ECE/TRANS/WP.29/GRE/2009/4
16 January 2009

REGULATION No. 53

Visibility of adaptive front-lighting systems (AFS) for motorcycles and glare

Proposal for Supplement 11 to the 01 series of amendments to Regulation No. 53

"Annex 6

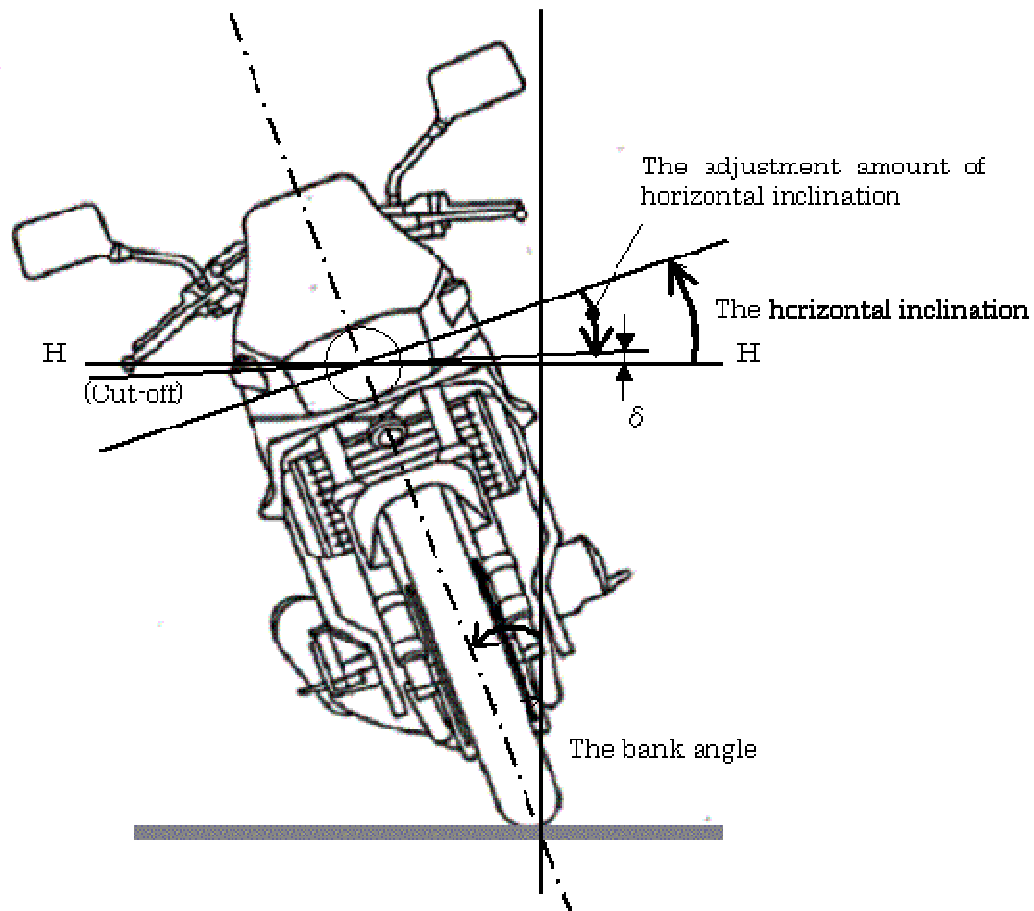
Insert a new Annex 6, to read:

EXPLANATION ABOUT "THE HORIZONTAL INCLINATION", "THE BANK ANGLE"
AND THE ANGLE " δ ".

Note : This figure shows the motorcycle is banked to the right side."

In the absence of specific instructions, test vehicle shall be set as specified in paragraph 5.4. Incline the vehicle with the following conditions and measure the angle δ created by headlamp cut-off line (in case of asymmetrical beam headlamp, its horizontal part of cut-off is used) and HH line. (see drawing in Annex 6).

The system shall be considered satisfying the requirements of paragraph 6.2.5.5., if all measured angles δ are not less than zero. This may be demonstrated by the manufacturer by other means accepted by the authority responsible for type approval."

Figure 1. Description of the Function of the Inclination Angle adjustment-Type AFS

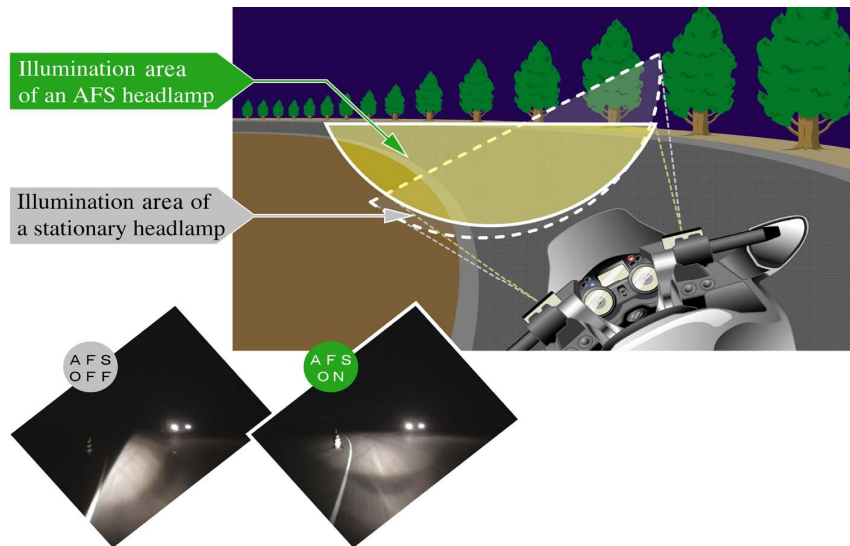
In the case of a motorcycle, due to its driving characteristics, the headlamp inclines with the vehicle when the vehicle is running on a curved road, narrowing the illumination area of the headlamp in the travelling direction. Therefore, by adjusting the variation of the headlamp's light distribution from that when the vehicle is upright (i.e.: in the standard condition), to keep the illumination area wide enough, the visibility is expected to improve.
